INVESTIGATION OF KENTUCKY)	
UTILITIES COMPANY'S AND LOUISVILLE)	
GAS AND ELECTRIC COMPANY'S)	
RESPECTIVE NEED FOR AND COST OF)	CASE NO. 2015-00194
MULTIPHASE LANDFILLS AT THE)	
TRIMBLE COUNTY AND GHENT)	
GENERATING STATIONS

STERLING VENTURES RESPONSES TO SUPPLEMENTAL DATA REQUESTS OF KENTUCKY UTILITIES COMPANY AND LOUISVILLE GAS AND ELECTRIC COMPANY

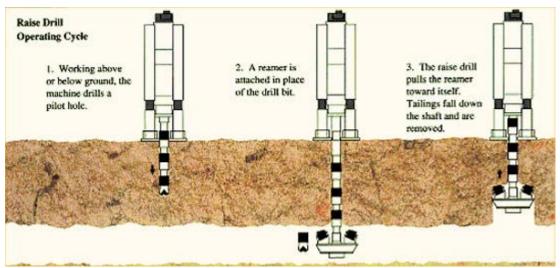
12. Provide the estimated cost, timing, and location of construction of the shaft referenced by Mr. Gardner on pages 16 and 17 of his pre-filed direct testimony, and provide the estimated dimensions of any such shaft, including the shaft's depth and diameter.

RESPONSE: Sterling will locate the shaft on their property such as to minimize CCR haul times while minimizing interference with the aggregate production and sales operations. Also as stated in previous testimony, the shaft will be located with consideration of the geological constraints. Details of the shaft construction will depend on the delivered volumes and consistency of the CCR materials, however, at this stage we theorize that the proposed shaft might have an external diameter of 14 to 20 ft, and could be grouted or concrete lined depending on conditions encountered. The shaft would be built using the technique called raise-boring, which is illustrated in the following schematic:

The shaft will be approximately 350 feet in depth. Typically, the average advance in construction of the greatest potential size of 20-ft shaft is 3 ft/day; therefore, it is estimated that it could take a maximum of approximately 120 days to construct the shaft. The cost of the shaft will be the responsibility of Sterling and is included in the proposed pricing.
